ACE Board Rev 1.0: Build Notes

The work an ACE Board Rev 1.0 needs beyond its bill of materials, for a new build or for upgrading a built board. Rev 1.1 makes these fixes on the PCB. On Rev 1.0 you make them by hand.

Figure 1. Top of the ACE. Where each change is. Change 5 is in two places: the ATmega, U6, and its pull-up under U4.

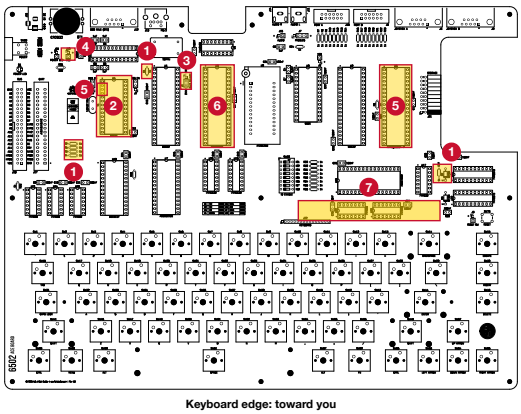
Change	Who needs it
1	Fit 10 kΩ at R1–R5 and R27, not 1 kΩ	Every board
2	Fit an R6551AP at U4	Every board
3	Keep J1 on its 1 MHz pins	Every board
4	Add a 10 µF supply capacitor on the underside	Every board
5	Program the AB Controller firmware, and add a 10 kΩ pull-up on RESB	Firmware: every board. Pull-up: recommended
6	Stack a socket on U3 and fit a diode for /INT	Any pico9918 video card
7	Fit the ACE RAM Patch Rev 1.1 in place of U12 and U13	Any board with the banked RAM (U15, U21, U22)

Figure 2. R2–R5, beside the CART connector. Note the order: R2, R5, R3, R4.

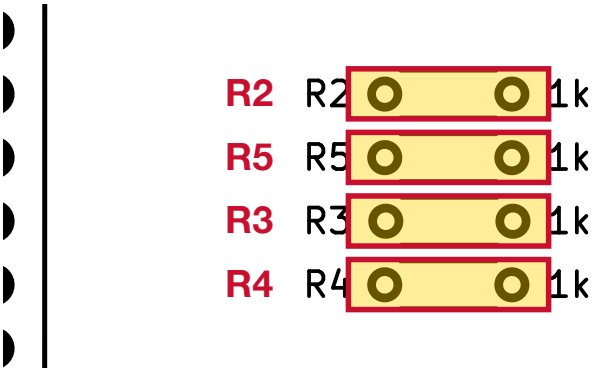
Rev 1.0's BOM lists 1 kΩ at these six places. Rev 1.1 makes five of them 10 kΩ and removes R1. R2, R5, R3 and R4 pull up shared lines: BE, RDY, NMIB and IRQB. A 1 kΩ pull-up draws 5 mA, more than the 3.2 mA the 65C22's IRQ output is rated to sink. R27 pulls up the banked RAM's chip enable (U15 pin 22). R1, beside U1's top left corner, holds SOB (U1 pin 38) high. Nothing else holds that pin, so don't leave R1 out. Every other 1 kΩ on the board stays 1 kΩ, including R6, which is the ATmega's reset pull-up.

- [ ] R1, R2, R3, R4, R5: 10 kΩ.
- [ ] R27: 10 kΩ.

Figure 5. The capacitor across J19's pads, lying flat. Underside of the ACE, keyboard edge toward you.

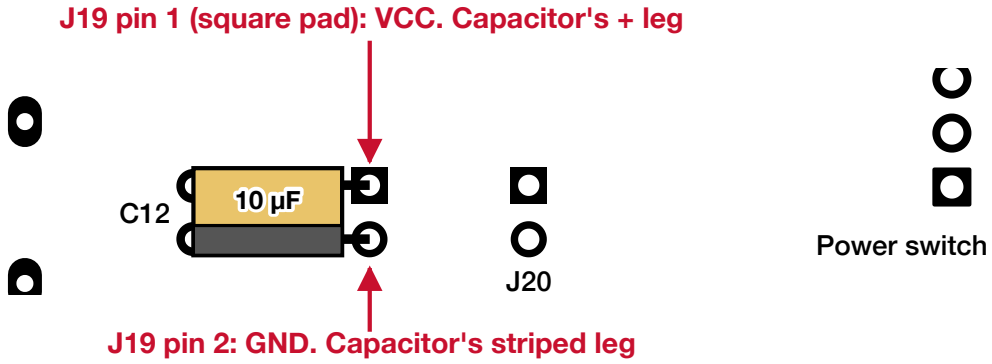
Rev 1.1 adds a 10 µF electrolytic across VCC and GND beside the power input, as bulk capacitance for the whole board. Rev 1.0 has no holes for it, so it goes on the underside, across the pads of J19, the VCC header. J19's pads are close to the power switch and 2.54 mm apart, and J19 can still be fitted. Rev 1.0's own C20 is a 100 nF capacitor elsewhere on the board: leave it alone.

- [ ] Bend the legs to 2.54 mm. Positive leg to J19 pin 1 (VCC), striped leg to J19 pin 2 (GND).
- [ ] Lay the body flat on the board, so it stays clear of the plate. Its insulated sleeve can rest on C12's joints. Solder the legs to the pads, or to J19's tails if J19 is fitted, and clip them.

Figure 6. The RESB pull-up on the underside, keyboard edge toward you. U4's pin 1 is nearest the connectors.

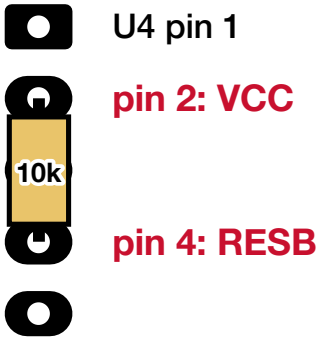
The ATmega's internal pull-up raises RESB on its own, but a 10 kΩ is stiffer on a line that runs out to CART and BUS. Rev 1.1 has one. On Rev 1.0, U4's pins 2 and 4 are VCC and RESB, 5.08 mm apart, the same pitch as a resistor footprint.

- [ ] 10 kΩ across U4 pin 2 and U4 pin 4, on the underside. Pin 3 is between them: keep the legs off its joint.

Figure 7. Find pin 16: the fifth pin up from the keyboard end of U3's left row.

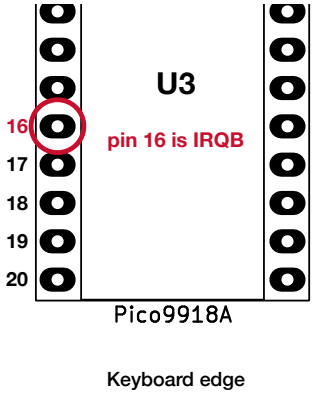
U3 pin 16 is the video chip's /INT, and Rev 1.0 wires it straight to IRQB. A TMS9918A's /INT is open-drain, but every pico9918 drives it high as well as low, and holds IRQB at about 3.8 V while the VIA tries to pull it low. Keyboard and serial input are then dead. This affects the PRO and the v1.3 alike: a v1.3 can appear to work, but only by luck. Rev 1.1 has a diode on the PCB. Rev 1.0's PCB has no place for one, so it goes in a socket stack: a second socket between U3's socket and the card, with pin 16 routed through the diode.

- [ ] Take a machined-pin DIP-40 socket: this is the riser. The pico9918's pins are solid and can't be bent or cut, so the change is made here.
- [ ] Count to pin 16 on the riser, with its notch the same way as U3's. Cut off pin 16's tail below the plastic, so it can't reach U3's socket.
- [ ] Solder the BAT85's band end (cathode) to what is left of the riser's pin 16.
- [ ] Put the other leg (anode) into U3's socket at pin 16, and press the riser into U3's socket. Keep the diode under the card or on the board beside U3's left row, with its legs clear of the other pins.
- [ ] Check with the meter's diode test, with the card out: red on IRQB (R4's left leg, Figure 2), black in the riser's pin 16. About 0.3 V this way, and open the other way.
- [ ] Fit the card into the riser, with its pin 1 at the connector end. It now sits one socket higher: check that it clears any top panel.

Figure 9. Top of the ACE, keyboard toward you. The patch's four parts run in one row: U1, J1, J2, U2. J1 goes in U12's holes and J2 goes in U13's. Pin numbers are marked on both sockets.

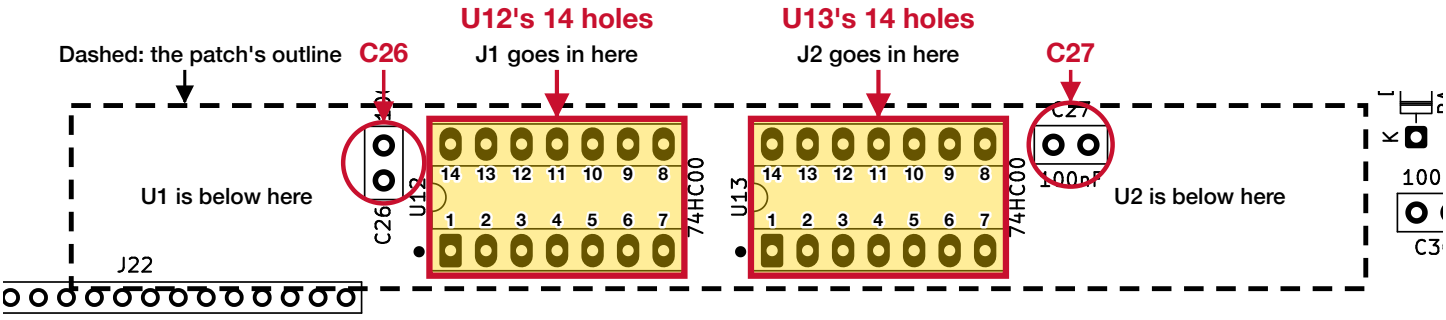
Rev 1.0's latches for the banked RAM load at the wrong times, so the RAM doesn't hold a bank. The patch is a small board that replaces U12 and U13. It mounts under the ACE on pin headers, with the same logic as Rev 1.1.

- ☐ U12 and U13 are empty: no chips and no sockets. On a built board, take them off. Take off an older Rev 1.0 patch or any other rework on this part of the logic.
- ☐ All 28 holes of U12 and U13 are open and clear of solder.

Figure 10. Underside of the ACE, keyboard toward you. Left and right swap, so U13 is left of U12. Red dots are the legs of C26 and C27. Numbered white circles show where the patch's U1 and U2 pins land, 2.54 mm below the ACE.

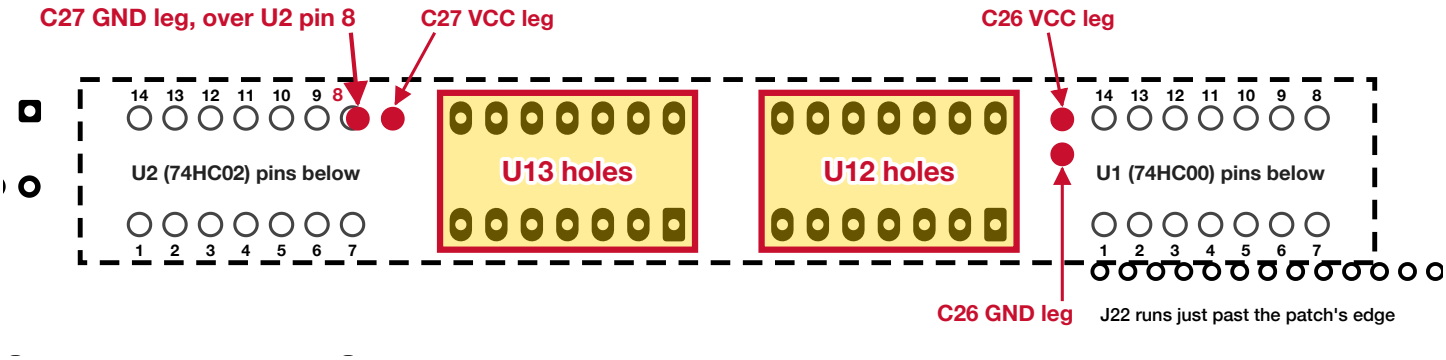
> **Watch C27:** its GND leg sits 0.38 mm off the center of U2 pin 8, with only the 2.54 mm header gap between them. U2 pin 8 carries the signal from U1 pin 8. If the leg touches the joint, that signal is shorted to ground. Step 2 deals with this.

- [ ] **C27 and C26:** clip all four legs to no more than 1 mm below the ACE. C27's GND leg matters most.
- [ ] The whole strip inside the dashed outline in Figure 10 is free of wires and parts.
- [ ] **J22:** its tails stand just past the patch's long edge, about 0.3 mm clear. Keep them straight.

Figure 11a. The patch's back: text upright. U2 (74HC02) is on the left and U1 (74HC00) on the right. Both have pin 1 at lower left, so both notches point left.

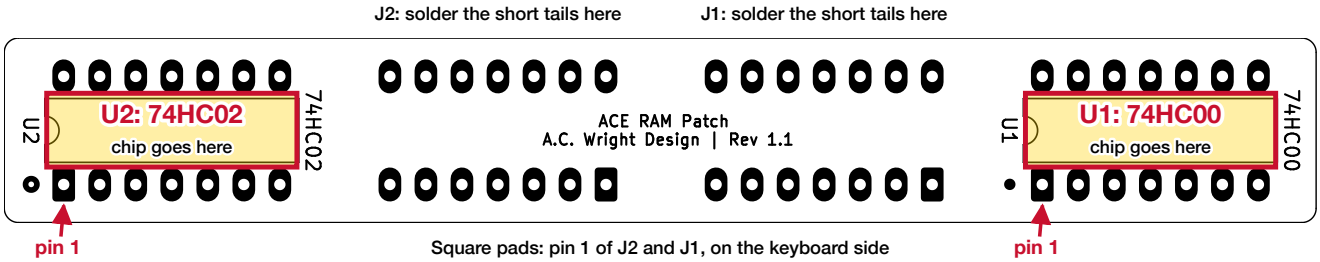
Hold the patch with its text side toward you and the text upright. This is the back. The chips go on this side.

- [ ] U2, the **74HC02**, on the left. U1, the **74HC00**, on the right. Check the markings: the two chips look alike.
- [ ] Notches to the left. Chips seated flat on the board. **No sockets:** a socket adds about 3 mm and the chip would hit the plate.
- [ ] Solder all 28 legs on the front. Clip them flush now: this side faces the ACE and you can't reach it later.

Figure 12. Steps 4 to 6: the ACE face down, seen from the keyboard edge (one row of pins, to scale). U2 is on the left in this view.

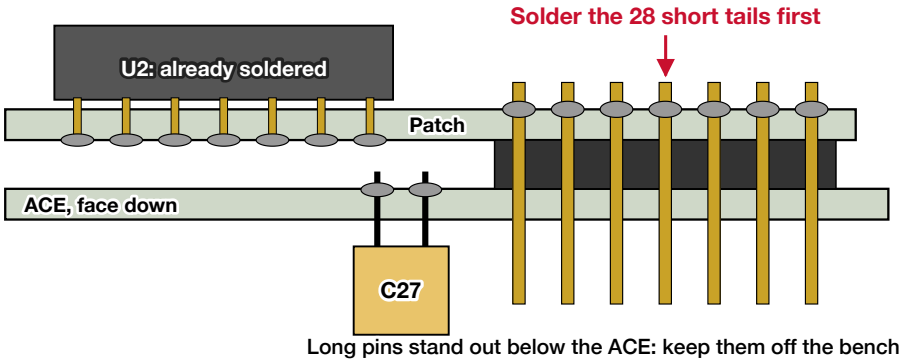
> **The patch also fits turned 180°, and that is wrong.** Every pin finds a hole, but VCC lands on GND (J1 pin 14 goes in U13 pin 7). Check all of these before any solder:

- [ ] Keyboard edge toward you, and the text on the patch reads **upright**.
- [ ] U2 (74HC02) on your left and U1 (74HC00) on your right.
- [ ] The patch's square J1 and J2 pads are on the keyboard side, under the ACE's square U12 and U13 pads.
- [ ] C27's and C26's legs don't touch the patch. Look through the gap with a light.

Figure 13. The finished stack, ACE on top, seen from the keyboard edge (one row of pins, to scale).

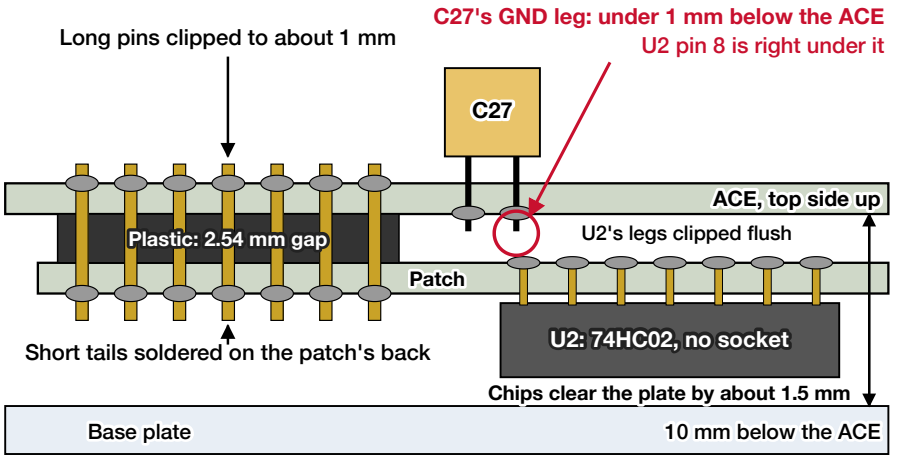
- ☐ The pins go in with finger pressure: use the strips.
- ☐ They need force: stop, and use round machined-pin header instead. Forcing a pin can damage the plated hole. Check that the chips still clear the plate (Figure 13).

- [ ] Turn the ACE face up. Hold it on blocks or its standoffs, so the patch hangs free. It hangs about 8.5 mm.
- [ ] Push the patch up, so the plastic is against the ACE's underside. Tack the end pins of each strip and check again.
- [ ] Solder the rest: 28 joints in U12's and U13's pads. Clip the pins to about 1 mm above the joint.
